# Wollongong Local Planning Panel Assessment Report | 1 May 2019

<b>WLPP No.</b>	Item 2
<b>DA No.</b>	RD-2018/533/A
<b>Proposal</b>	Residential - dual occupancy and Subdivision - Strata title - two (2) lots
<b>Property</b>	Lot 12 DP 1188169 7A Cochrane Road, THIRROUL
<b>Applicant</b>	Plannex Environmental Planning
<b>Responsible Team</b>	Development Assessment and Certification – City Wide Team (NA)

## ASSESSMENT REPORT AND RECOMMENDATION

**PRE-DEVELOPMENT - ADJOINING DWELLING**

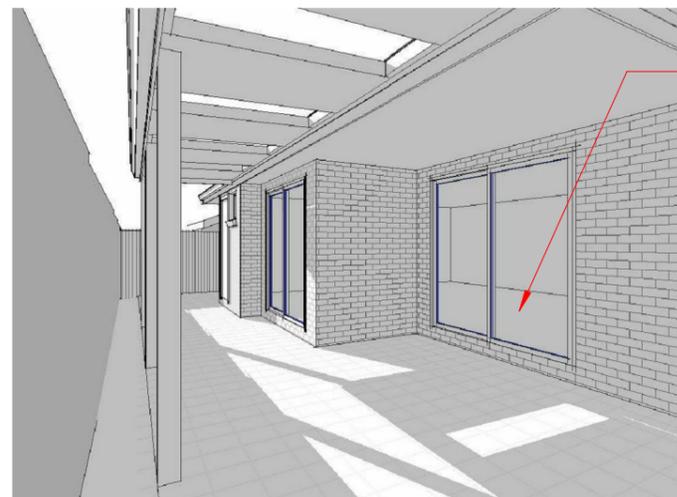
No solar access into living areas due to self shadowing by pergola. POS has less than 50% solar access and is reduced by existing fence and pergola - can be improved by removing pergola.

**PRE-DEVELOPMENT - ADJOINING DWELLING**

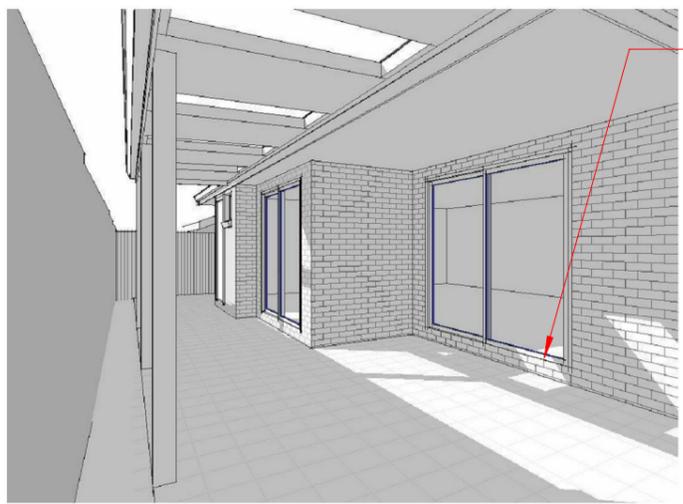
Increased solar access into living areas but could be dramatically improved if no self shadowing. POS has less than 50% solar access and is reduced by existing fence and self shadowing - can be improved by removing pergola.

**POST-DEVELOPMENT- ADJOINING DWELLING**

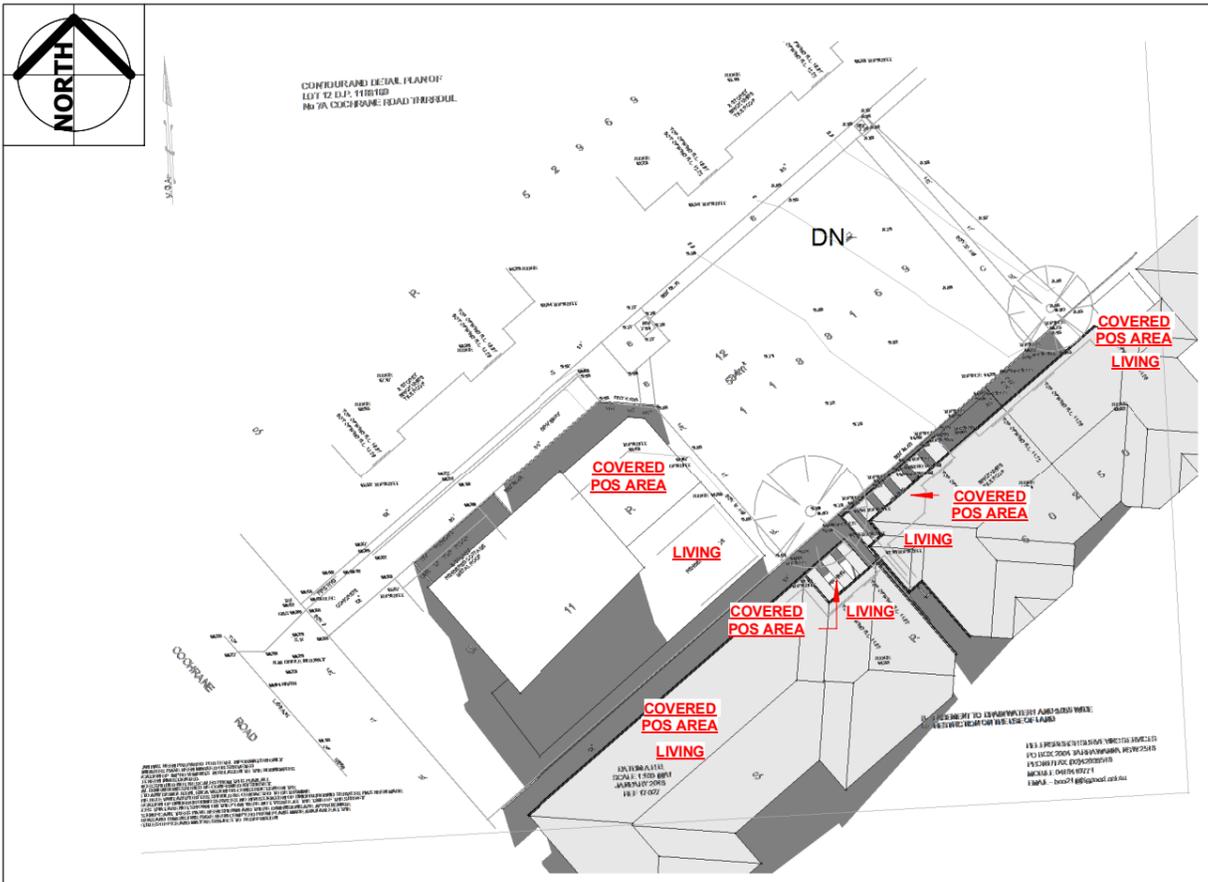
No impact from proposed development

**PRE-DEVELOPMENT - ADJOINING DWELLING**

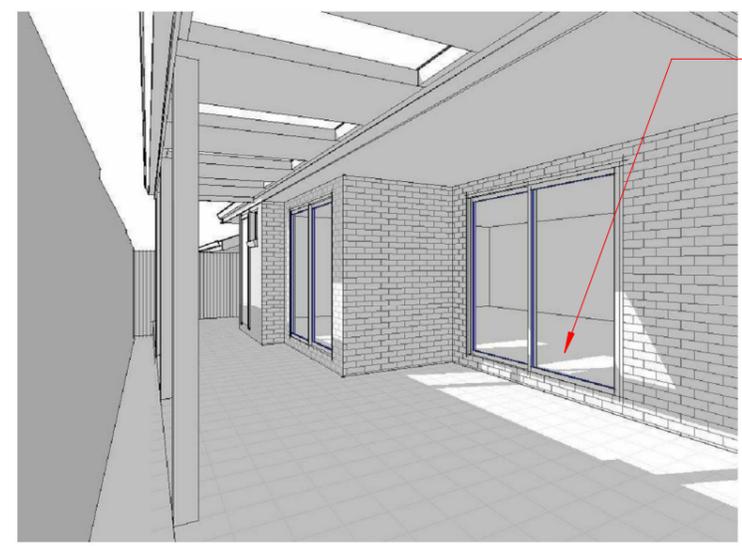
Increased solar access into living areas but could be dramatically improved if no self shadowing. POS has less than 50% solar access and is reduced by existing fence and self shadowing - improved if compliant.

**POST-DEVELOPMENT- ADJOINING DWELLING**

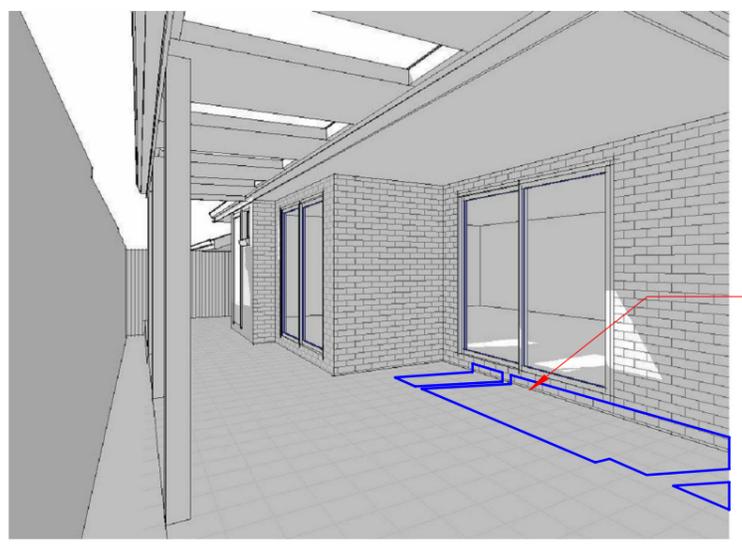
Minor impact from proposed development onto POS only. POS is overshadowed by fence & pergola - improved if compliant.

**PRE-DEVELOPMENT - ADJOINING DWELLING**

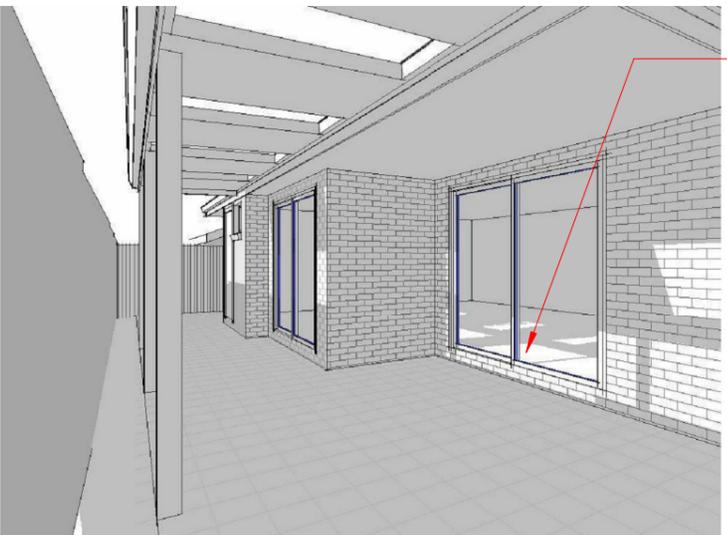
Increased solar access into living areas but could be dramatically improved if no self shadowing. POS has less than 50% solar access and is reduced by existing fence and self shadowing - improved if compliant.

**POST-DEVELOPMENT- ADJOINING DWELLING**

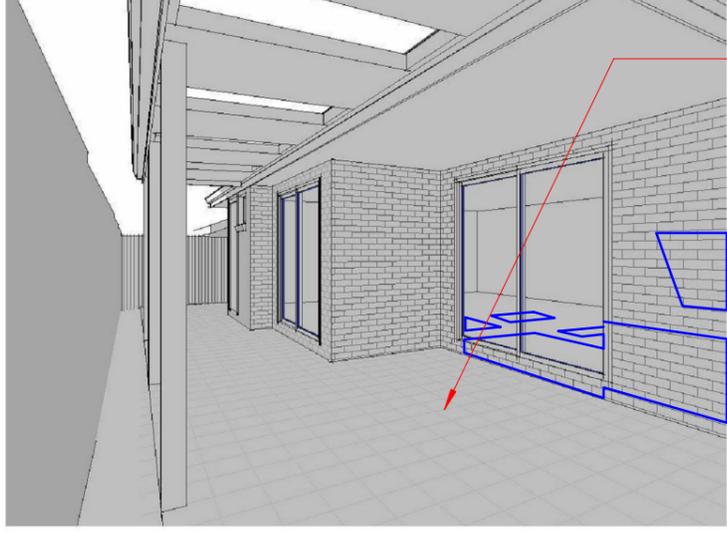
Reduced solar access into living areas but could be dramatically improved if no self shadowing. POS is entirely overshadowed by fence & pergola - improved if compliant.

**PRE-DEVELOPMENT - ADJOINING DWELLING**

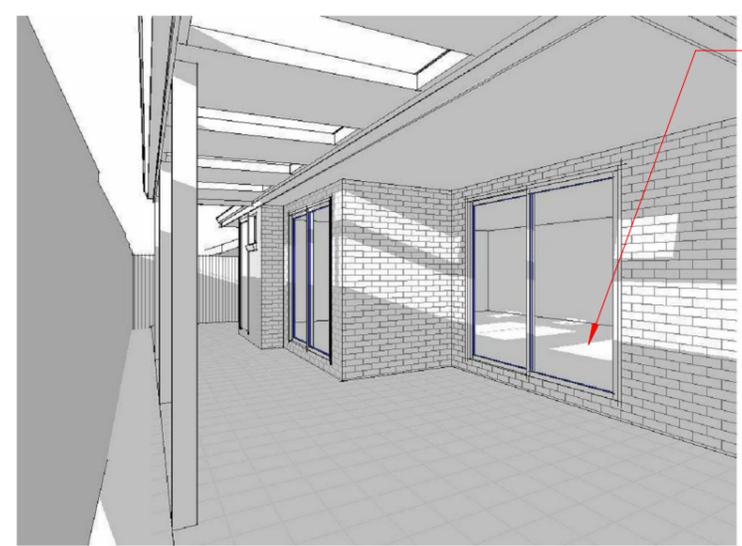
Increased solar access into living areas but could be dramatically improved if no self shadowing. POS has less than 50% solar access and is reduced by existing fence and self shadowing - improved if compliant.

**POST-DEVELOPMENT- ADJOINING DWELLING**

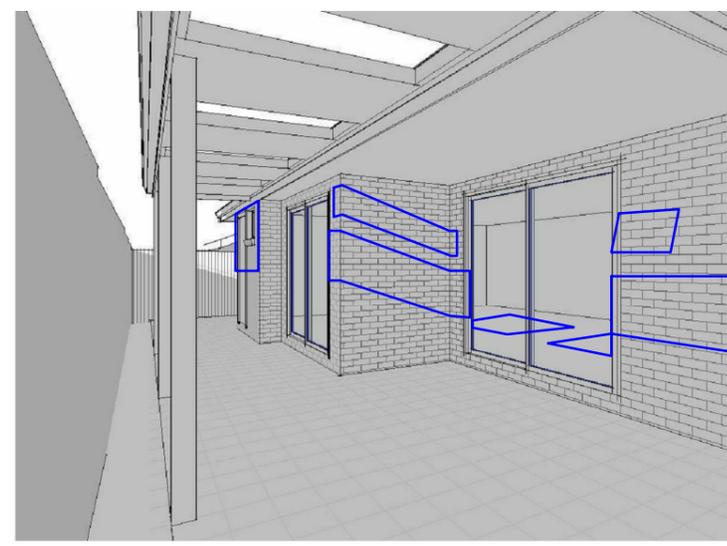
Reduced solar access into living areas but could be dramatically improved if no self shadowing. POS is entirely overshadowed by fence & pergola - improved if compliant.
